ADDENDUM NUMBER 02

DATE: 3/8/2023

PROJECT: MHS Band and Choir Renovation

PROJECT NUMBER: 22-1722

1 FIRST FLOOR - ELECTRICAL POWER PLAN
E1.1 SCALE: 1/8" = 1'-0"

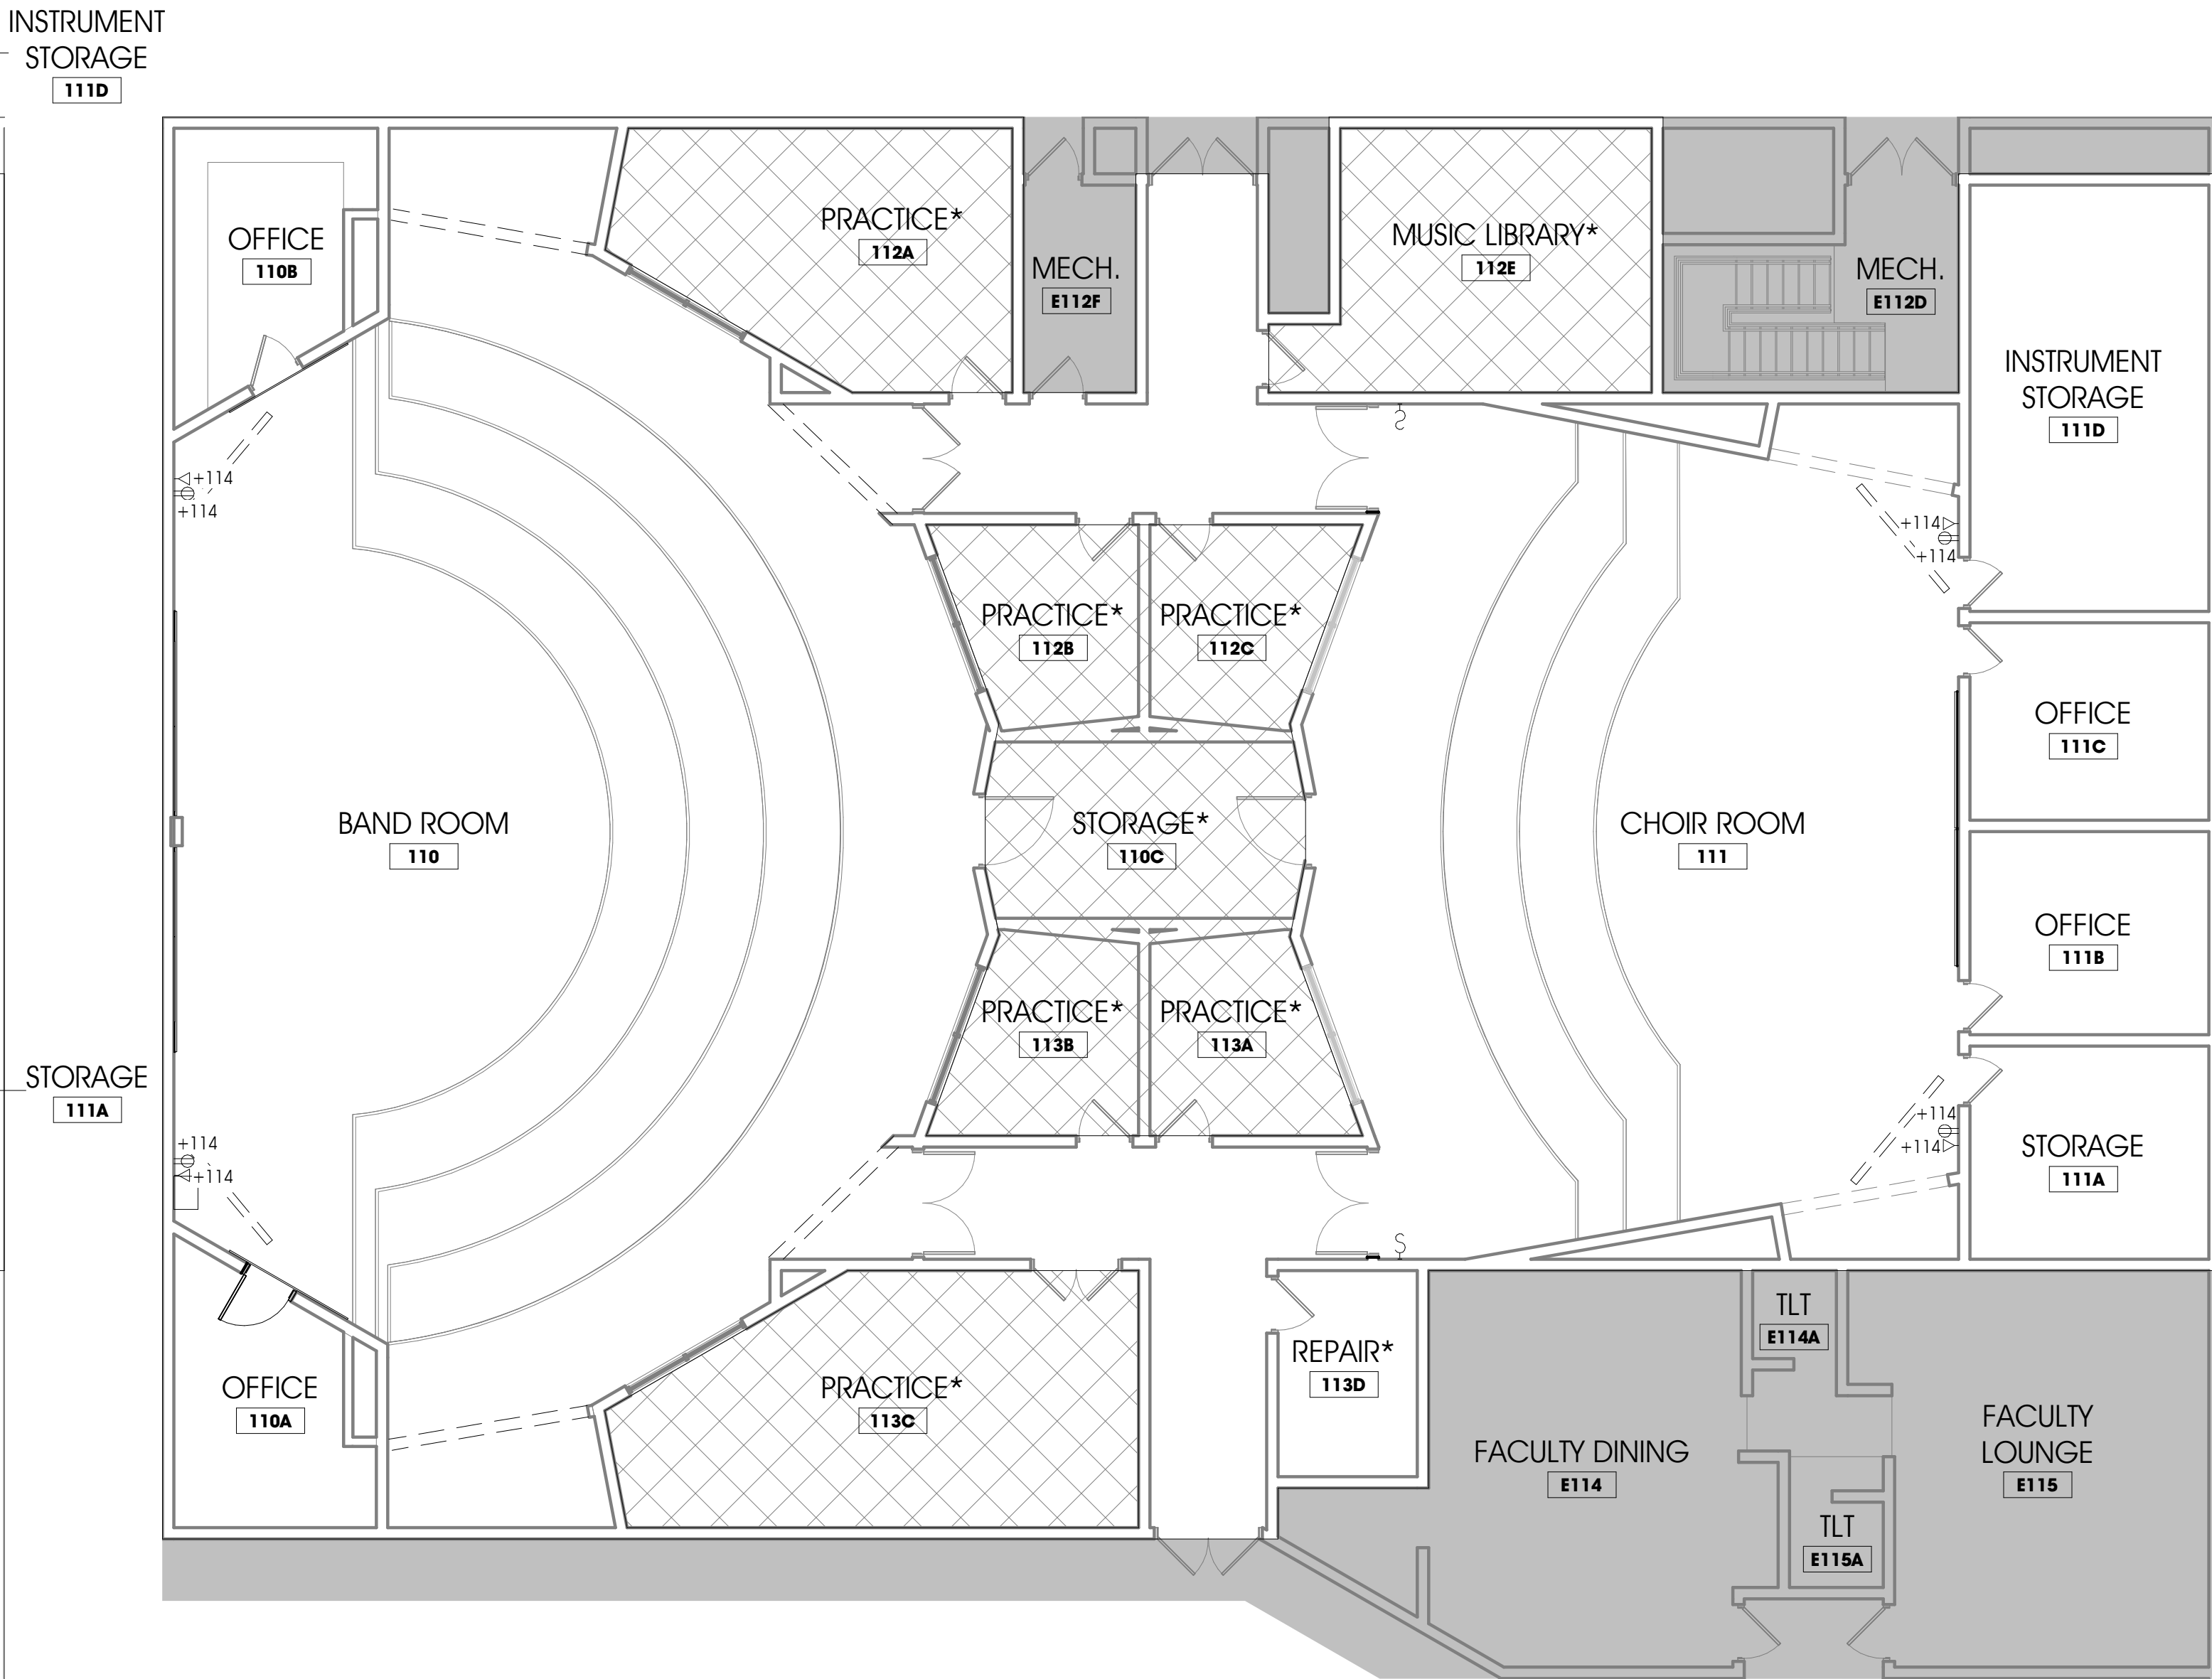
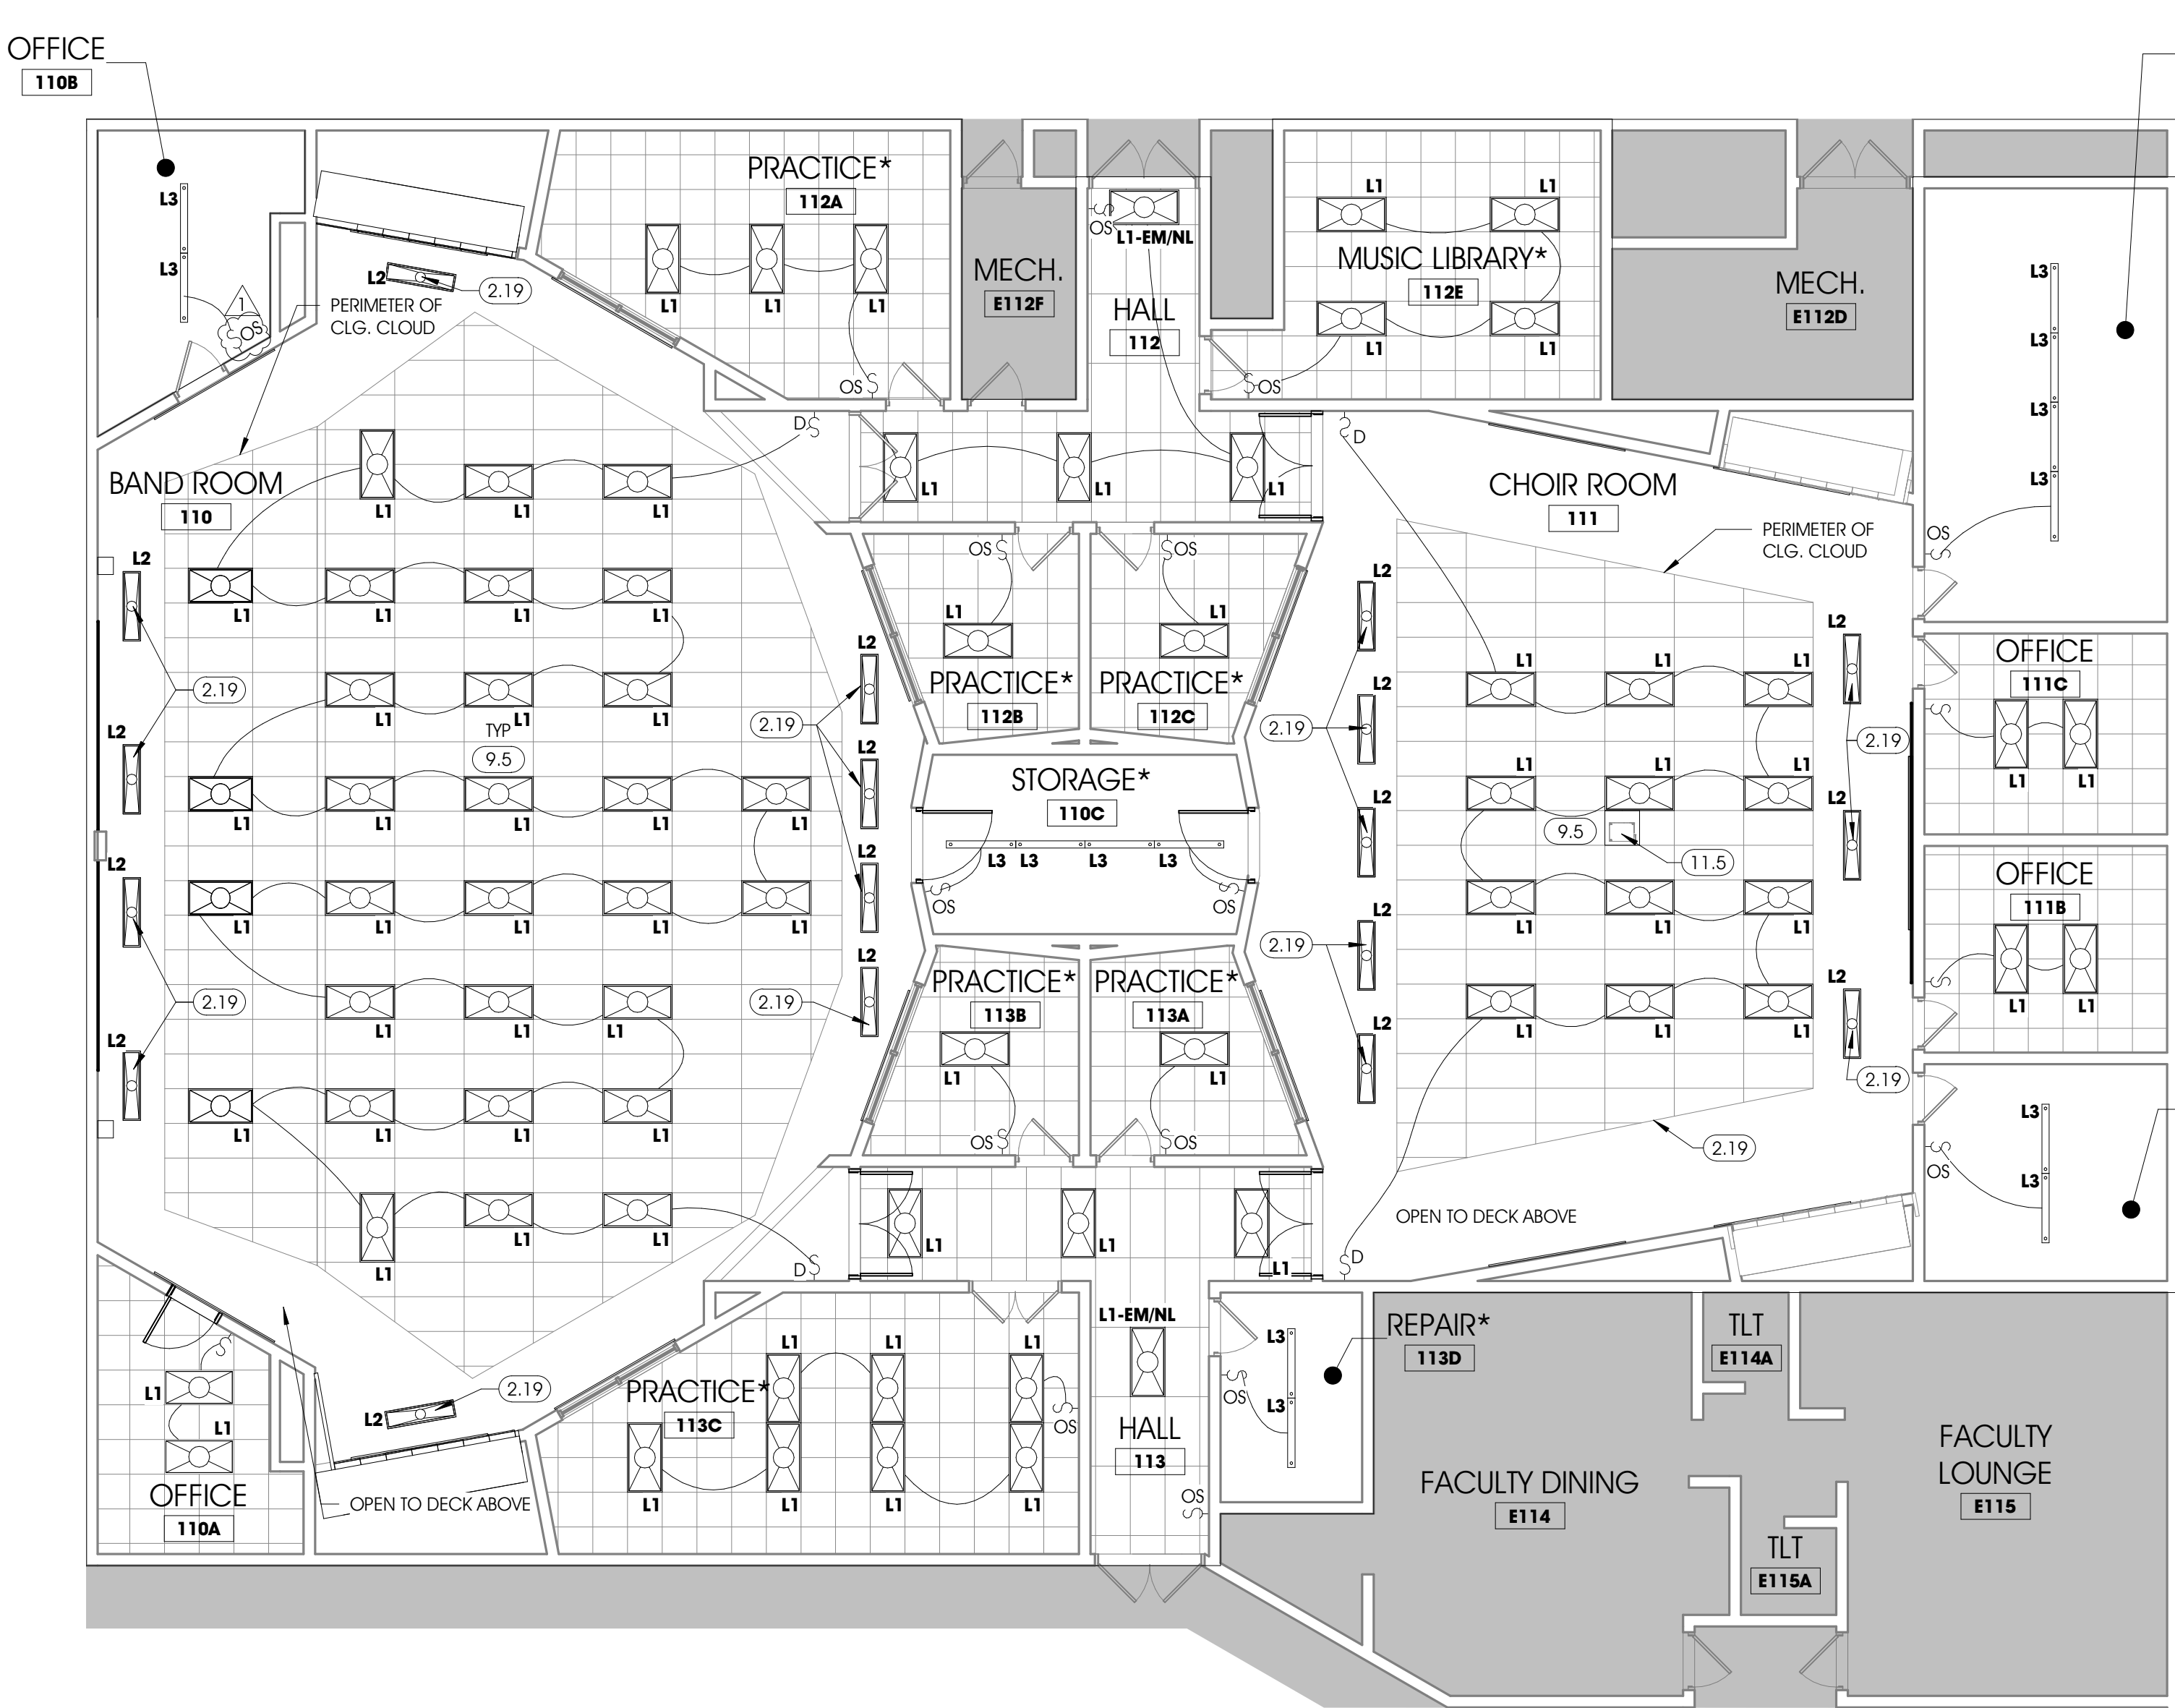
- 20) **ADD** occupancy sensor switch in office 110B.
